WORK ORDER NON-CONFORMANCE / UPDATE

Work Order: <u>150738</u>		DISPOSITION		AGAINST DEPARTMENT/PROCESS					
Part No. <u>D3016-3</u>		Rework ☐		Skid-tube ☐	Cross tube ☐	Water Jet ☐	Engineering ☒		
NCR No. <u>16-6050</u>		Scrap ☐		Machining ☐	Small Fab ☐	Prod. Eng. Coord. ☐	Quality ☐		
		Use-as-is ☒		Thermoforming ☐	Finishing ☐	Rec/Store/Packaging ☐	Other ☒		
		Suspected Unapproved ☐		Large Fab ☐	Composite ☐	Supplier ☐			
Date: <u>16/9/22</u>		Step #: <u>120</u>		QTY Effective: <u>20</u>			MRB (QSI042) Approval		
Description Work Order Deviation				Disposition			Completed By		
PART WAS CUT PER WELDERS REQUEST. ENDS WERE LEFT WITH FULL ARC. PRODUCES IDENTICAL WELDED JOINT AND REPRESENTS HOW ASSEMBLY HAS BEEN MADE IN THE PAST.				Acceptable. PART ASSEMBLED PART IS IDENTICAL IN STRENGTH & GEOMETRY. CAR 16-156 created to request Eng to update D3016 dng per manufacturing.			<u>16/9/22</u> Lead hand / Supervisor Approval Verification <u>16-09-22</u> QC / QA Coordinator Approval <u>16-09-22</u>

DESIGN <i>CP</i>	DRAWN BY <i>CP</i>	DART AEROSPACE LTD HAWKESBURY, ONTARIO, CANADA	
CHECKED <i>#</i>	APPROVED <i>#</i>	DRAWING NO. D3016	REV. A SHEET 1 OF 3
DATE 01.05.18		TITLE SEAT FRAME ASSEMBLY

D3016-11 SADDLE

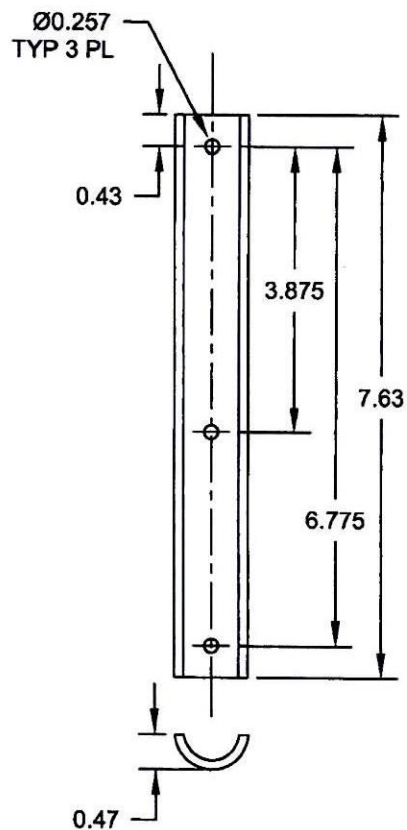
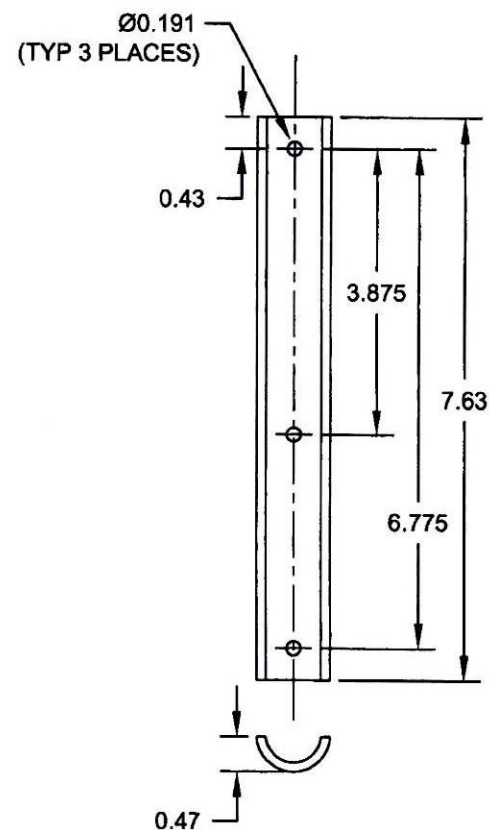
TO REVISE D3016-11 SADDLE'S HOLE SIZES

DETAIL D3016-11 SADDLE (SHEET 3): Ø0.257 TYP 3 PL WAS Ø0.191 (TYP 3 PLACES) AS SHOWN:
